TOWN OF YARMOUTH
200 Main Street, Yarmouth, Maine 04096
www.yarmouth.me.us

Planning Board Report
90 Main Street
Preliminary Development Plan, Building & Lot Plan, Major Site Plan, and Major Subdivision
Charles Hewitt and Katherine Carey, Applicants
Map 32 Lots 7 and 11; CD-4 Village Center Character District
Prepared by Erin Zwirko, Director of Planning and Development
Report Date: December 8, 2022; Planning Board Date: December 14, 2022

Existing Conditions Plan Showing Zoning Districts from Conceptual Submission

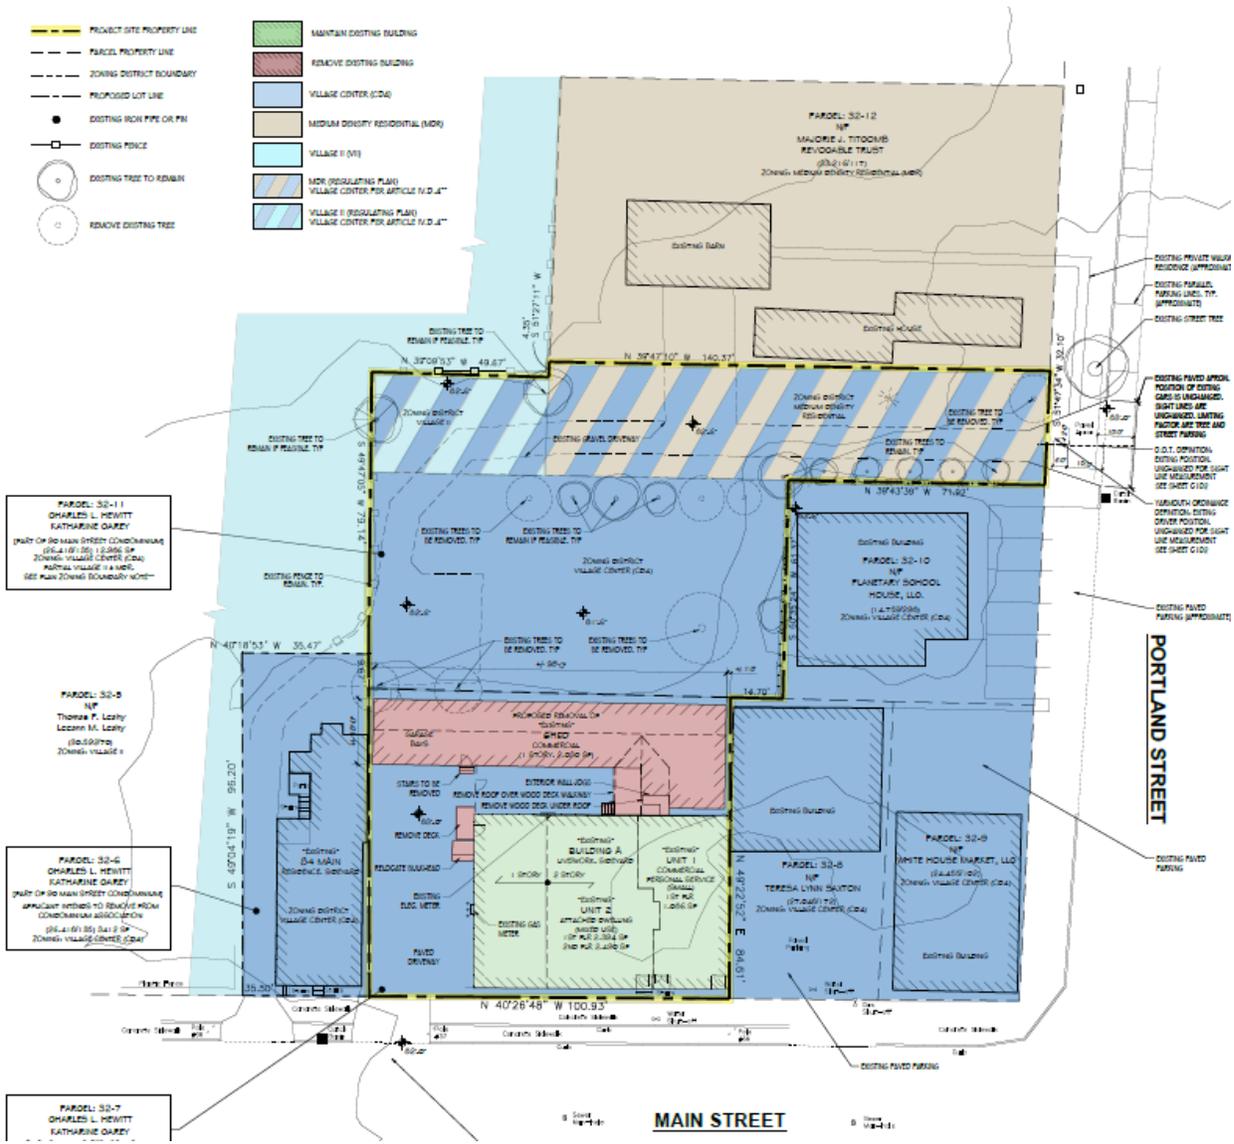
The application brings to light an apparent discrepancy between the property boundaries shown on Yarmouth's tax maps and the documentation provided by the applicant regarding the property lines. Because of this discrepancy, the rear parcel (32-11) is shown as being zoned partially Village II and Medium Density Residential District (MDR). The applicant writes, *"The parcel behind 90 Main St., which is described as "Tax Map 32 11", is depicted on Yarmouth's Regulating Plan as being rectangular and "landlocked" without access to Portland Street. The deed for the property, dated October 20, 1960, describes the property as including a leg extending to Portland Street which gives a right of way to 12 Portland Street (32-10) and (32-6). When the deeded parcel, see the Survey dated November 2021, is overlaid on the Yarmouth Regulating Plan the parcel is bisected by three Zoning Districts. The majority of the parcel is in Village Center (CD4), the Driveway to Portland Street is in Medium Density Residential (MDR) and a small corner is in Village II. See Sheet C101 for visual representation. A tall stockade fence exists on the site today and roughly follows the property line behind Lot 32-5."*

It is likely if the Town had the property boundaries depicted accurately on the tax maps, the CD4 Village Center Character District would have extended to the property lines shown in the application materials. However, since there is this discrepancy, the Planning Board may look to a provision in the Zoning Ordinance regarding properties split by zoning districts (Article IV.D.4):

Applying this provision to the property under consideration leaves a 2 foot 1 inch portion of the property that remains as Village II and MDR. Additional information may be sought if the Planning Board has questions of the applicability.

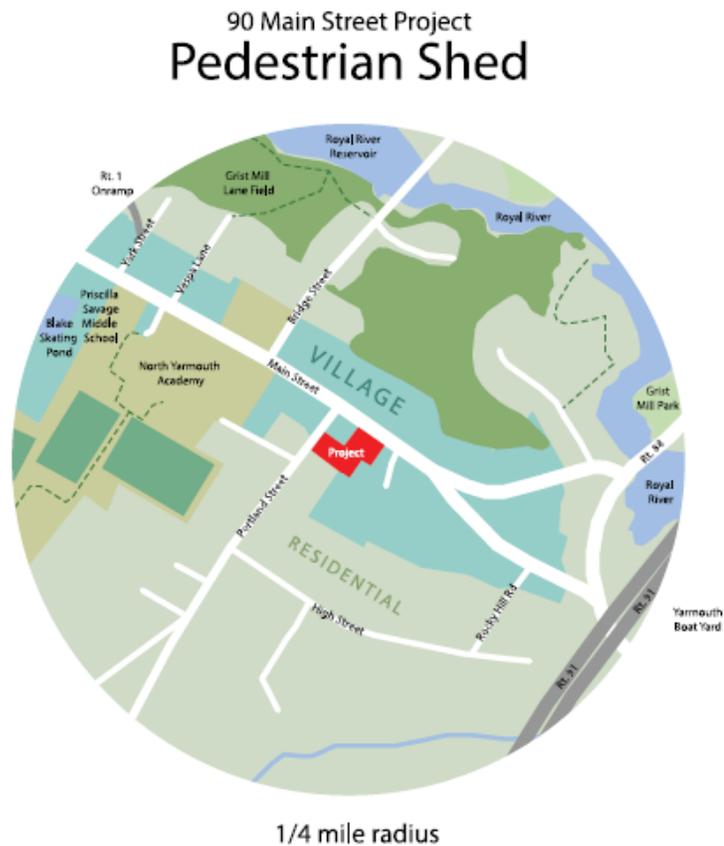
The applicant has provided an analysis of the Alley Thoroughfare standards as well as the waivers required. In addition, the applicant has provided an assessment of the Lane Thoroughfare for comparison documenting that the Lane would also require waivers. An Alley is not an exact match to the site plan, but the Lane Thoroughfare requires more waivers than the Alley.

Attachment: YWD Redlined Site Drawing

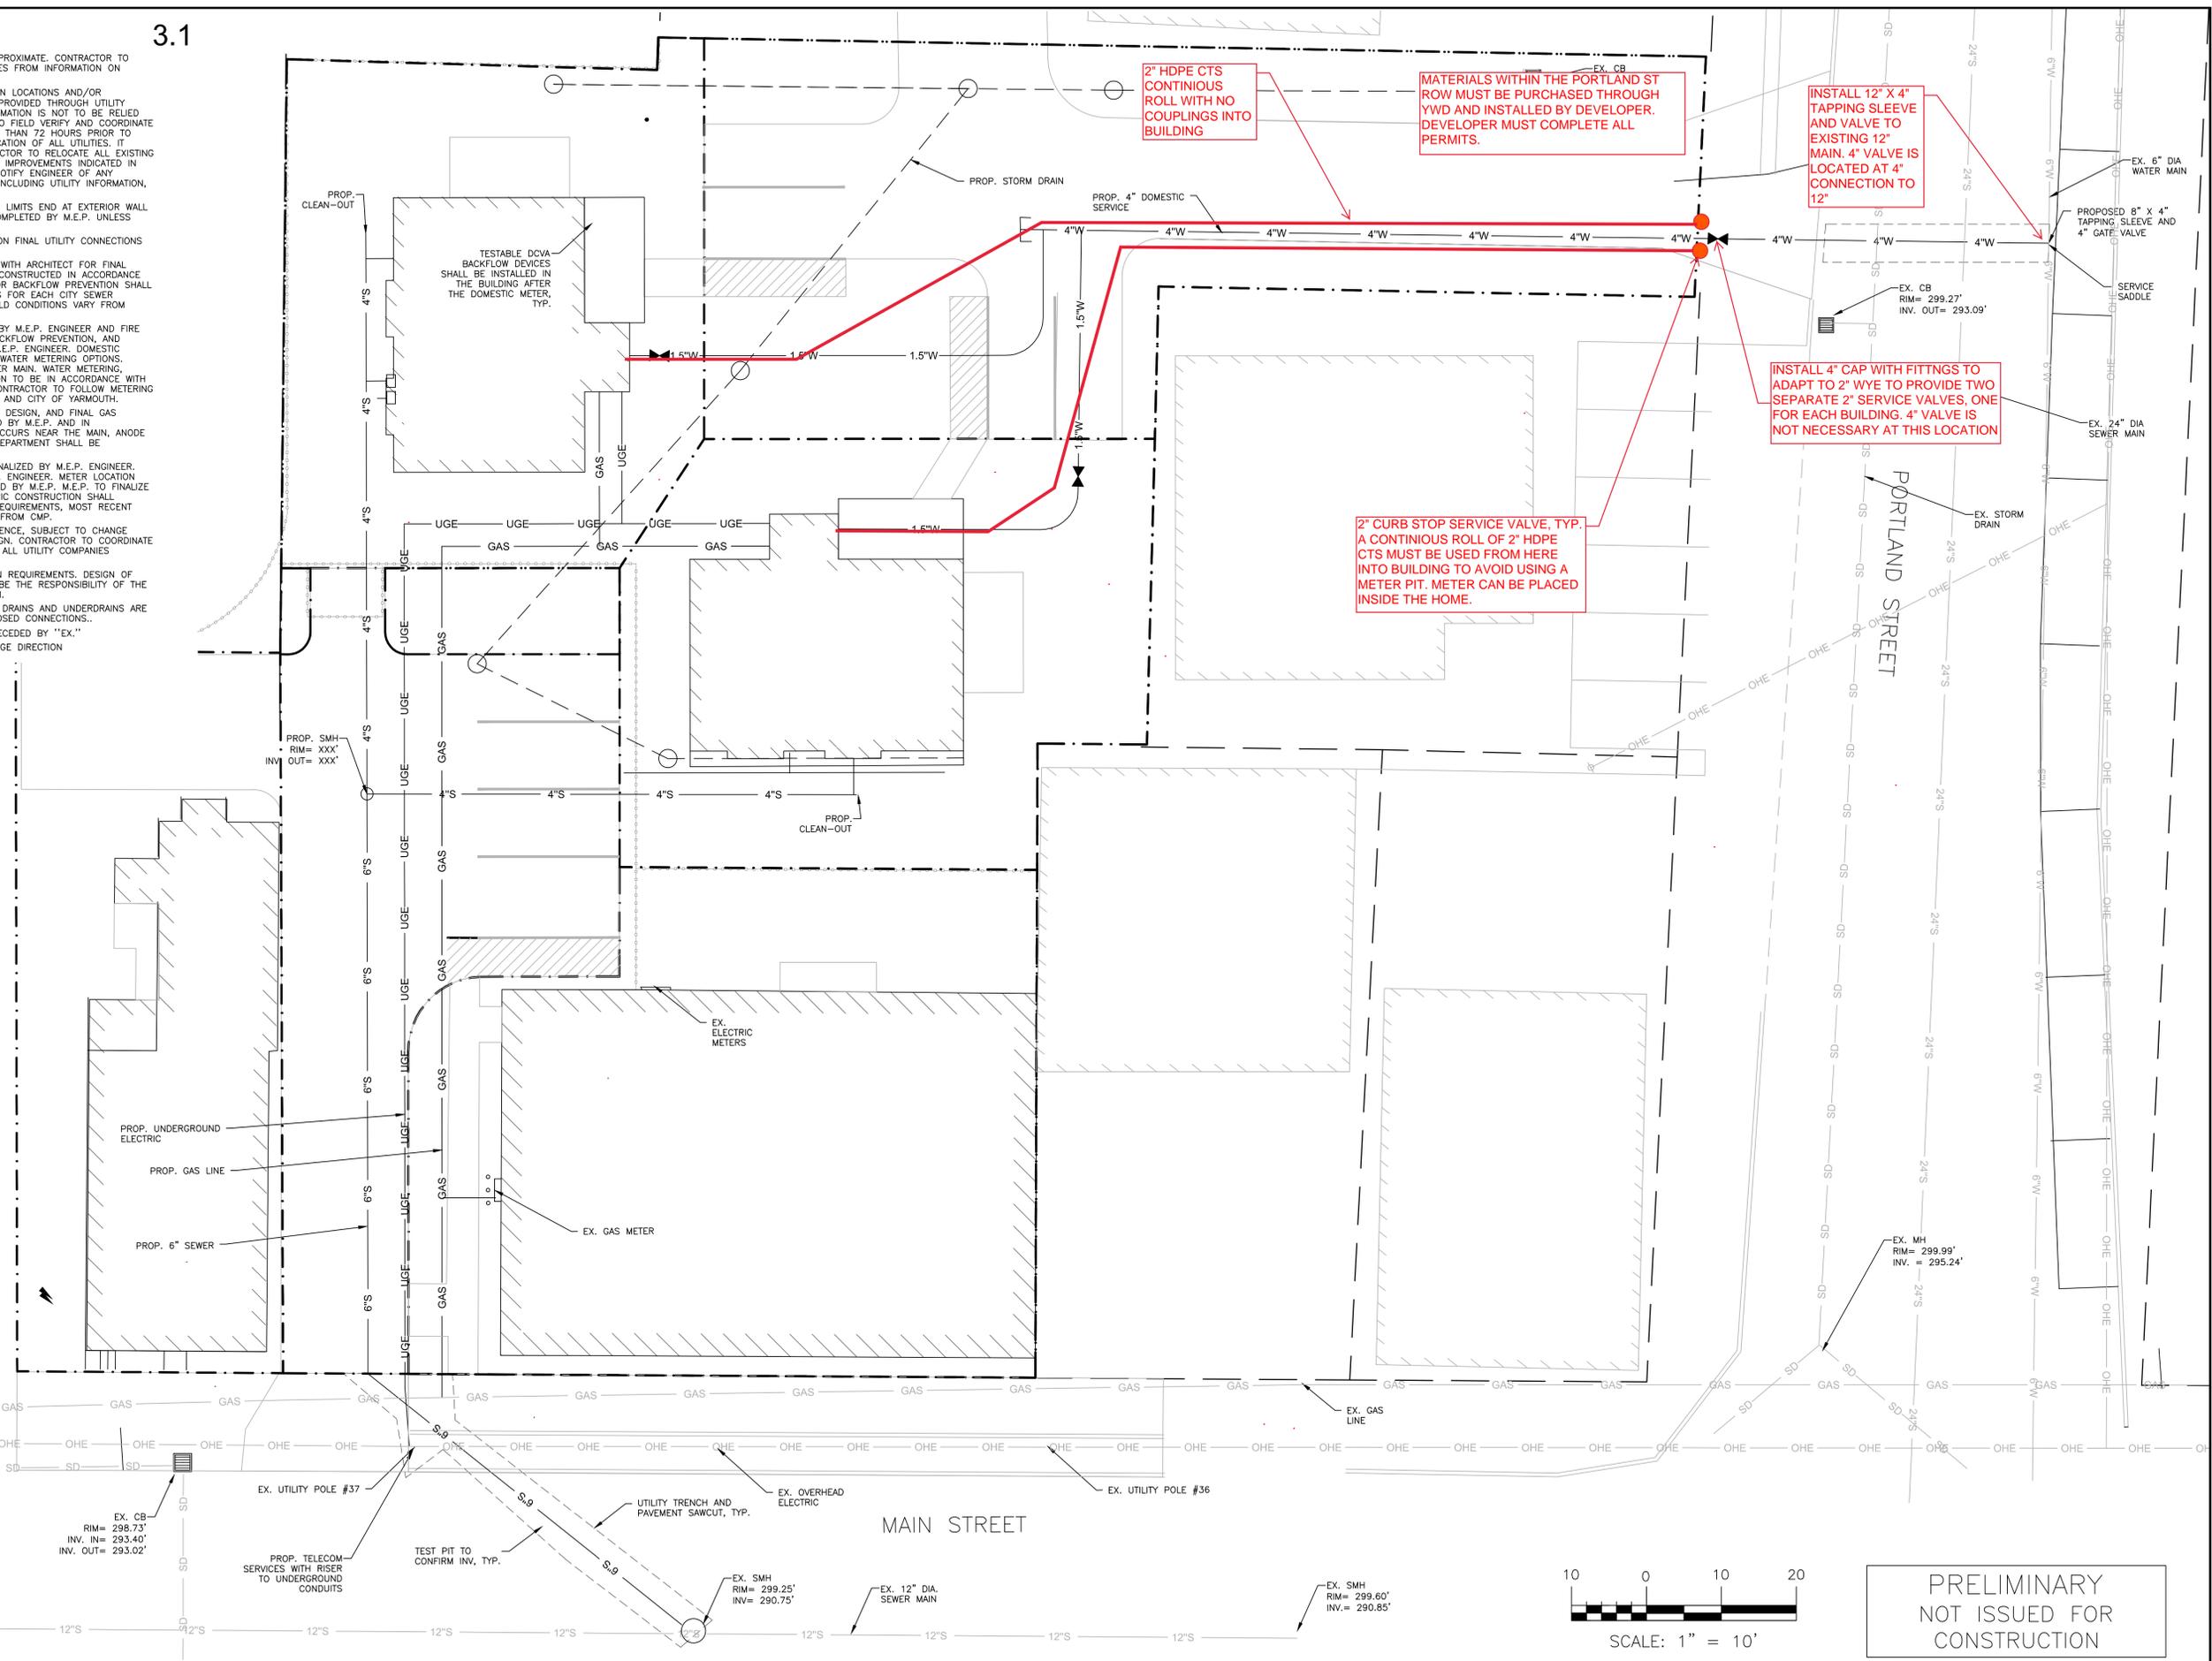
A capacity to serve letter has been received from the Yarmouth Water District (YWD). YWD indicated that the service can be extended from the main in Portland Street, which can be branched into two new services for each residence. The applicant will need to provide sprinkler flow rates for the new residences to ensure each meter is appropriately sized. This can be a future condition of approval.
